**APPEAL TO
PLANNING COMMISSION
HISTORIC LANDMARK COMMISSION DENIAL OF A CERTIFICATE OF APPROPRIATENESS
REVIEW SHEET**

CASE NUMBER: HR-2021-085739 HISTORIC LANDMARK COMMISSION: March 22, 2021, postponed
April 26, 2021, postponed
May 24, 2021, feedback provided
July 26, 2021, denied
August 24, 2021

HISTORIC NAME: Mitchell-Robertson Building (C14H-2004-0008)

ADDRESS: 909 Congress Avenue

Option 1 - Brace into Lot

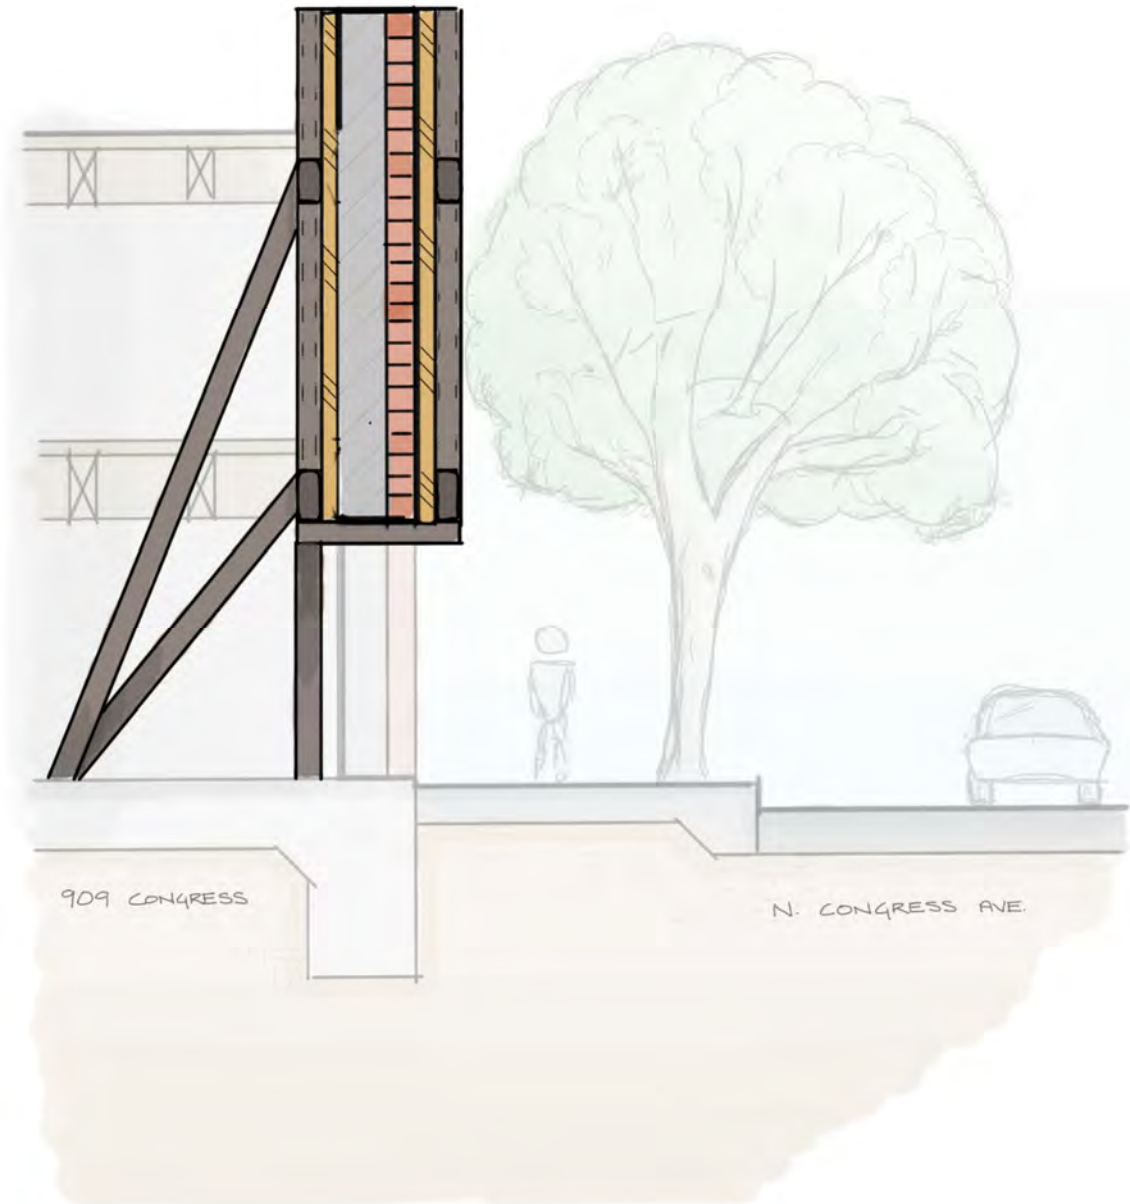
A steel frame structure with plywood sheathing could be utilized to sandwich the area of brick façade to be saved. This would allow for a structure that is stiff enough to not cause irreparable damages to the brittle façade. This steel structure would then have to be laterally braced towards the lot and away from Congress Avenue using steel diagonal members that would bear on new foundations within the extents of the existing buildings to provide gravity and lateral support of the brick façade as demolition and construction occurs around it. Due to the extent of demolition required in and around this particular building, this option will likely not be feasible as contractors would likely not be able to complete their scope of work around the proposed bracing elements.

Option 2 - Brace toward Congress Avenue

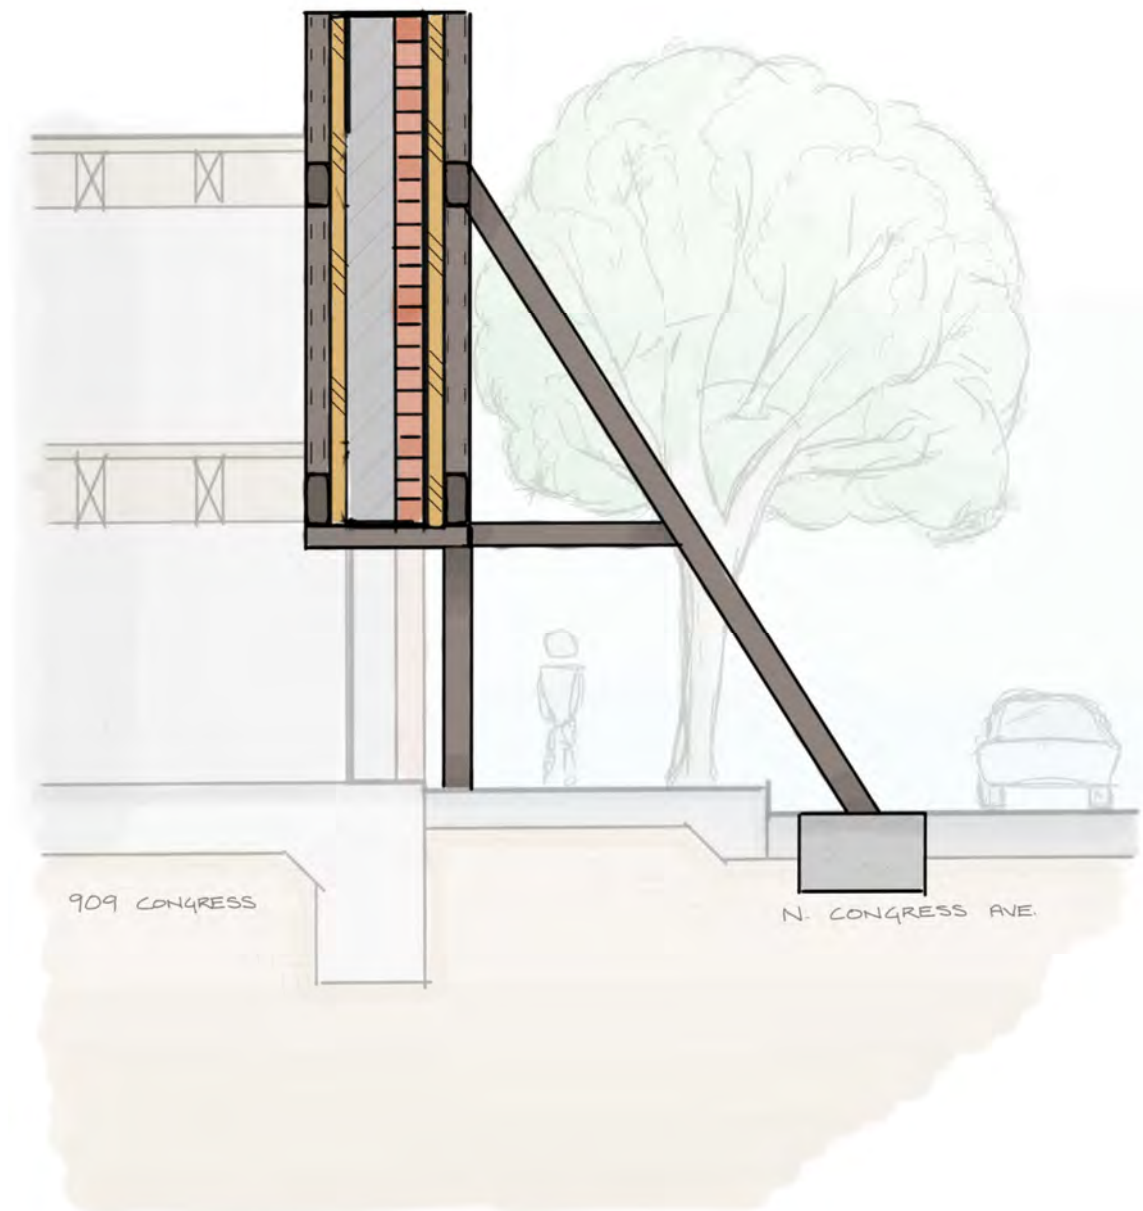
Similar to Option 1, a steel frame structure with plywood sheathing could be utilized to sandwich the area of brick façade to be saved. This would allow for a structure that is stiff enough to not cause irreparable damages to the brittle façade. This steel structure would then have to be laterally braced towards Congress Avenue using steel diagonal members that would bear on new foundations within the sidewalk or parking areas to provide gravity and lateral support of the brick façade as demolition and construction occurs around it. Bracing elements would have to be attached down through the sidewalk and/or the street parking spots for an extended amount of time until demolition and new construction are completed. This solution would cause significant interruptions to Congress Avenue and may incur excessive fines for impeding the right of way making this option improbable. Additionally, having the bracing elements in the public domain could increase the risks of accidents occurring that would cause distress and potential damage to the masonry.

Option 3 - Brace with Cantilevered Columns

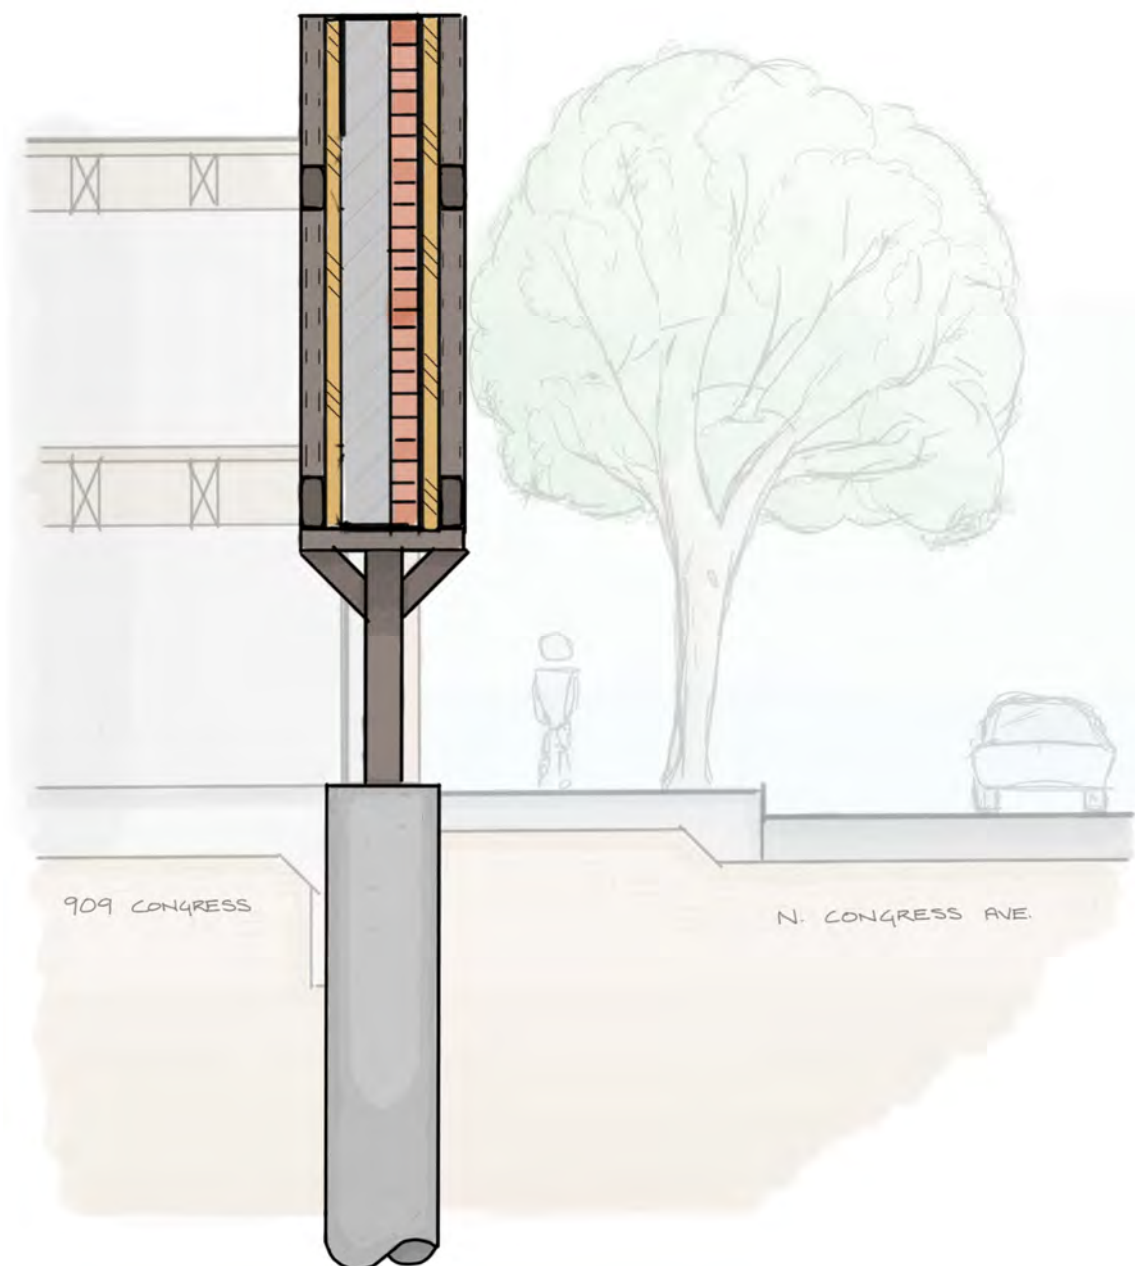
A similar steel frame structure as described in Options 1 and 2, but with far stiffer vertical elements as this option will not require any additional steel diagonal bracing for support. This steel frame will be supported from below with steel columns that are supported by a series of new concrete piers socketed into limestone. All steel elements will have to be designed to resist wind loads and provide adequate stiffness to prevent compromising the suspended masonry. Concerns with vibration during construction of the forthcoming development present a significant concern to the weakened masonry that might not be able to withstand consistent disturbance that is standard for a construction site. It is the opinion of this office that the vibration and general disturbance caused during construction may very likely cause irreparable damages to the masonry while it is being suspended in place. Additionally, drilling the concrete piers directly below this brick façade as part of the bracing installation may also cause vibrations that damage the façade.
